Helen Eldridge
Clerk Keresley Parish Council
c/o Keresley Community Library,
Bennetts Road,
Keresley End,
Coventry
CV7 8HX
clerk@keresley-pc.gov.uk

Re: Planning Application (Reserved Matters (Major)) RMM/2022/0633

Location: Land at Fivefield Road and Tamworth Road, Coventry,

APPENDIX 1:

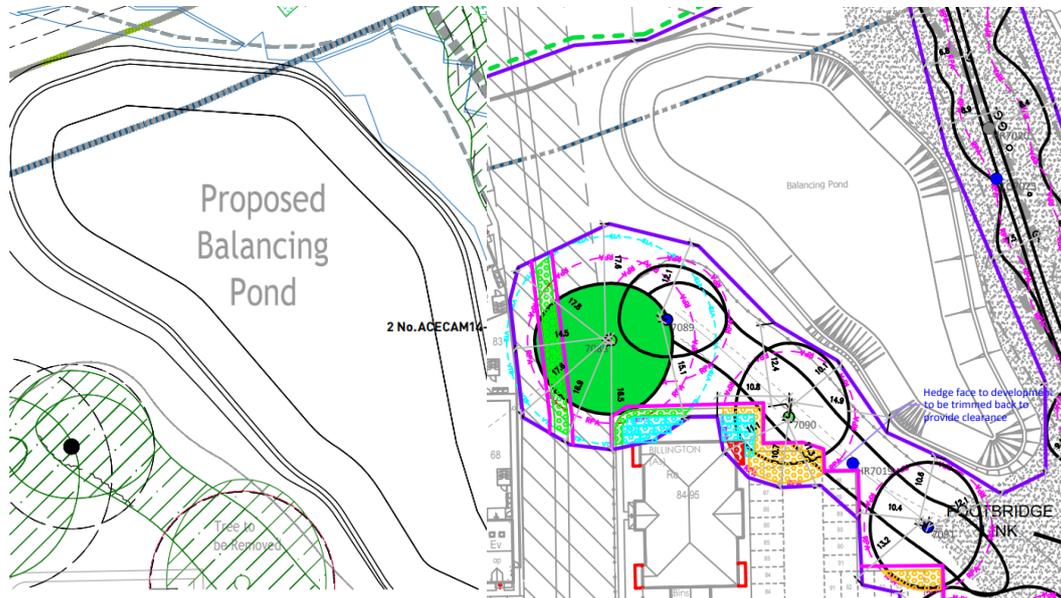
The loss of a Pedunculate Oak tree (7090 – Category A Quality, High Value) near a balancing pond is not welcome. There is a discrepancy in the documents about the fate of this tree. The [Detailed POS Landscape Proposals - Sheet 1 of 4 - Drawing No.P21-3416-03](#) state it is to be removed. Whereas [Tree Protection Plan Over Layout - Sheet 2 - Drawing No.37-1044.06](#) have stated it is to be retained with a no dig zone around it when building plots 84-95. See APPENDIX 1. No reason has been stated for its removal. For the sake of making foundations easier to dig, it does not justify the removal of this tree.

Discrepancies regarding 7090 tree removal (Pedunculate Oak – Category A Quality, High Value)
[Detailed POS Landscape Proposals - Sheet 1 of 4 - Drawing No.P21-3416-03](#)
[Tree Protection Plan Over Layout - Sheet 2 - Drawing No.37-1044.06](#)
